## South Central Railway

**Sub:** Issue of RDSO Modification Sheet no. RDSO/PE/MS/TL/0090-2023 (Rev.0) for provision of individual MPCB for water pumps and shifting of its controller to onboard in set of panels for LHB Non-AC EOG/HOG coaches as per RCF specification no. EDTS 355 Rev.1 with Am no. 1-2. -reg

MODIFICATION FOR PROVISION OF INDIVIDUAL MPCB FOR WATER PUMPS AND SHIFTING OF ITS CONTROLLER TO ONBOARD IN SET OF PANELS FOR LHB NON AC EOG/HOG COACHES.

MODIFICATION SHEET NO. RDSO/PE/MS/TL/0090-2023 (Rev 0)

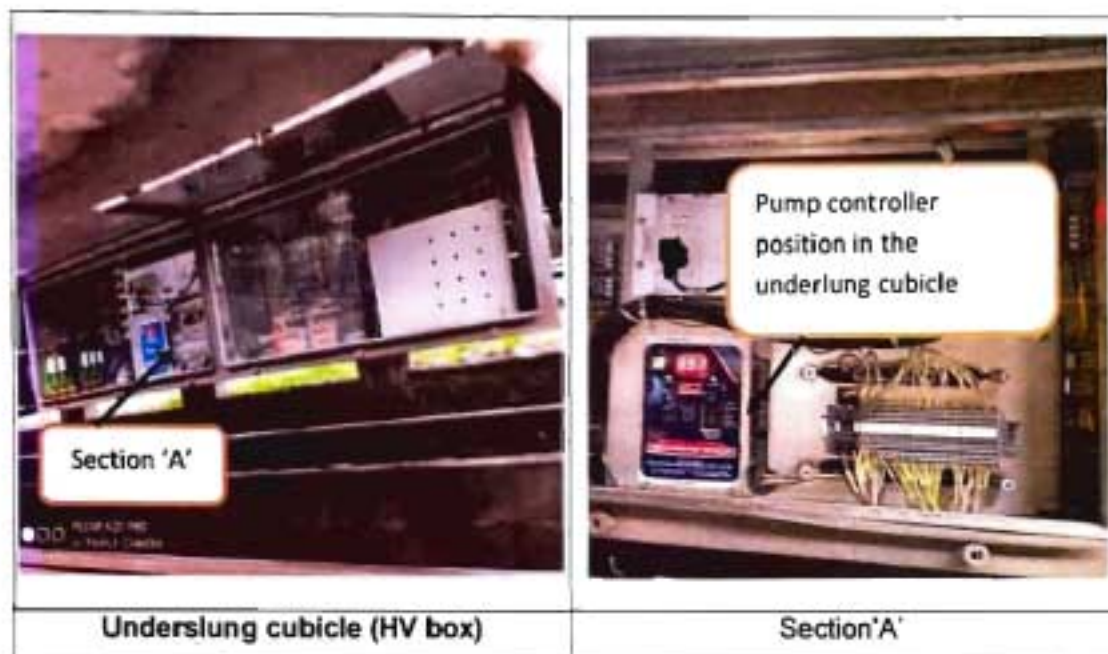
#### 4.1 Shifting of the Pump Controller from underslung cubical to on-board cubicle:

##### 4.1.1 Status of Pump Controller: At present, status of Pump controller in underslung HV cubicle is as under

##### 4.1.2 Shifted Position of the Pump controller:

- The shifted position of the pump controller in the onboard panel shall be as per the location shown in drawing no. RCF drawing no. CC72081 marked in red ink (Annexure A).
- The input of the pump controller i.e. 110 V DC shall be taken from the onboard panel from the main positive/negative fuses.
- The output of the pump controller shall be routed through the onboard panel end-fittings, secured with sleeves/conduits and grommets. These wires shall be guided to the underslung panel and the connection to respective switchgears shall be as per RDSO drawing no. RDSO/PE/SK/TL/0241-2023 (Rev.0) (Annexure B).

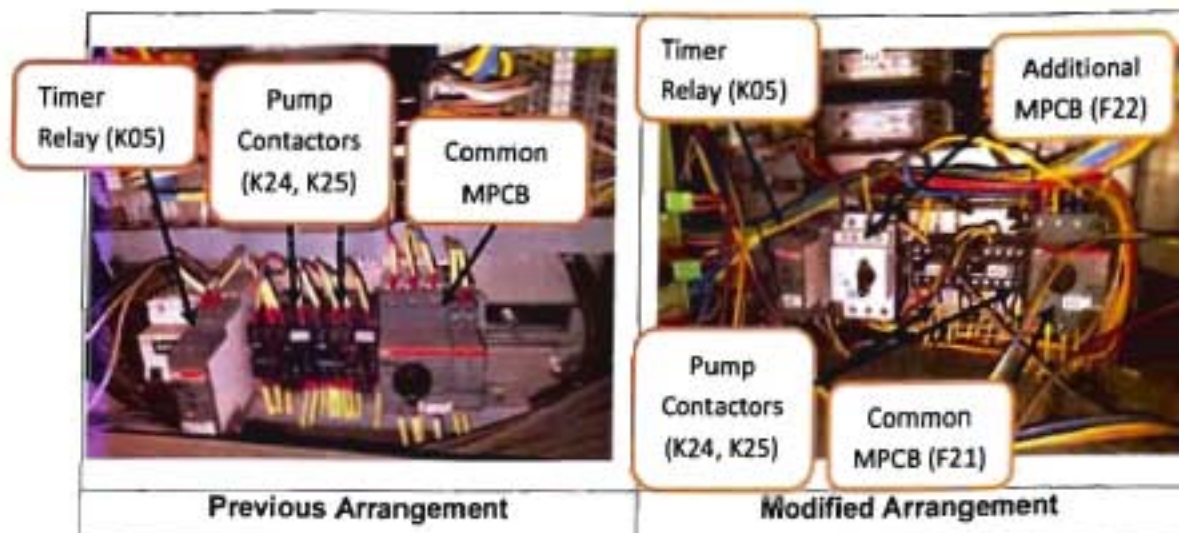
- The power terminals of 415V, 3 phase supply of pump 2 shall be shifted from outgoing of existing MPCB. This connection shall be connected to the outgoing terminal of additional MPCB. Further, the incoming of both the MPCBs to be looped and connected to main 3 phase supply of 415 V.
- The photographs of previous and modified status of MPCBs and interconnection are as below:

4.2.3 The interconnection of the MPCBs, contactors and pump controller shall be as per RDSO drawing no. RDSO/PE/SK/TL/0241-2023 (Rev.0) (Annexure B).
